## Aquatic Ecology Addendum Assessment

2 August 2024

**Subject: Oven Mountain Pumped Hydro Project – Aquatic Ecology Addendum Assessment**

**Figure 4.1** Temporary crossing structure locations

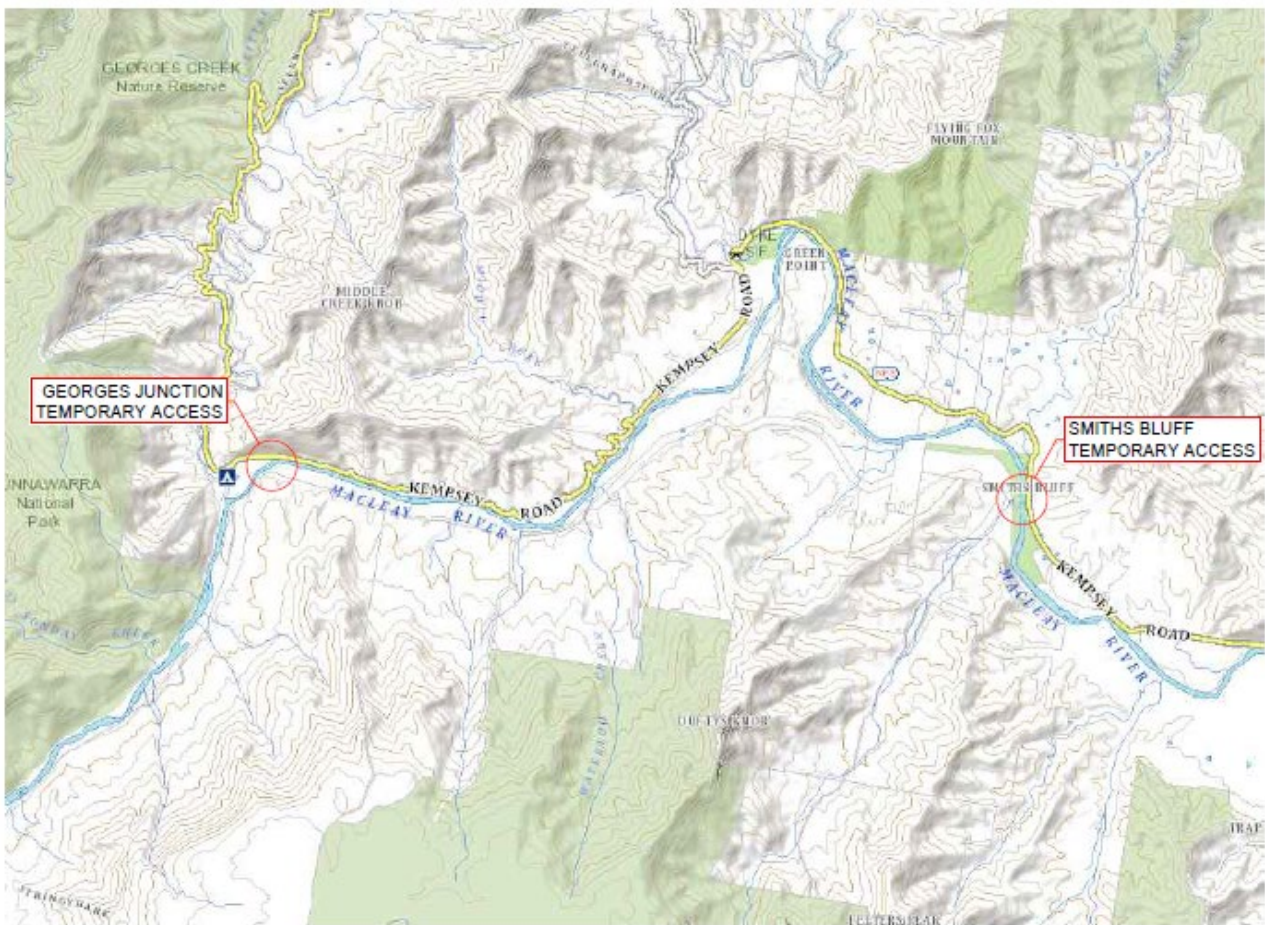
- to include an additional temporary bridge structure to cross the Macleay River about 600 m north east of Georges Junction
- re-location of the temporary bridge at Smiths Bluff immediately north of the proposed permanent bridge.

Two temporary bridges will be constructed during the construction phase until the permanent crossing structures are completed due to access requirements. The temporary crossing structures are located 600 m north east Georges Junction (referred to as the Western Access Temporary Bridge (WATB)), and on the Macleay River just downstream of the Georges Creek Confluence and Smiths Bluff near the downstream extent of the Project Area on the Macleay River (referred to as the Eastern Access Temporary Bridge (EATB)) (Figure 4.1). The purpose of the EATB will be to connect Kempsey Road to the Eastern Access Road prior to the construction of the permanent bridge. The purpose of the WATB will be to provide access to the Project site to allow road construction activities to be co-ordinated which will reduce the overall Project construction timing. The WATB will be removed at Project construction completion and not replaced with a permanent structure, whereas the EATB crossing will be removed once the permanent bridge structure is completed just south of the temporary structure and will be the main access into the Project Area.

**Table 4.2 Proposed temporary structures**

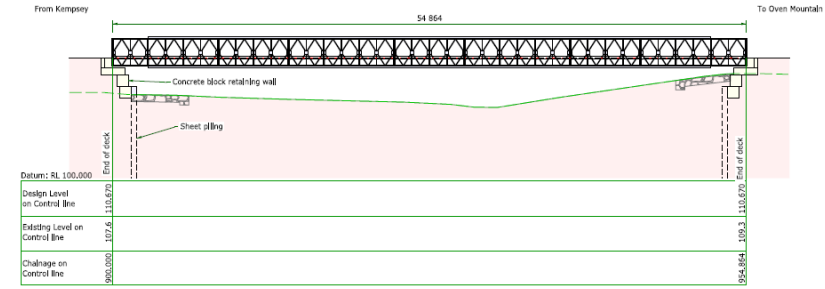
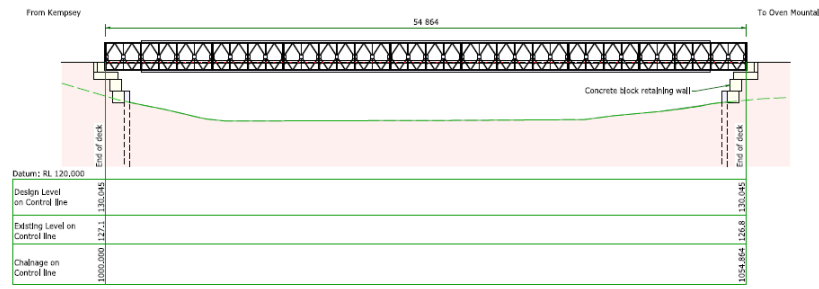
Both temporary structures will be single spanning structures (Table 4.2) and will be decommissioned prior to operation. The temporary structures at Smiths Bluff will be in place until the permanent crossing has been completed. The temporary structures for the crossing of Macleay River upstream of Georges Junction will be in place until the early road works are completed (this is assumed could be for approximately 4 years).

Both temporary structures will span the width of the Macleay River main channel without additional piers and or piles within the channels for support. Both structures will span the channel so that the low flow channel will be unimpeded maintaining habitat connectivity during low flow conditions. The abutments do encroach into the channel and may influence on the hydraulic function on this section of the river.
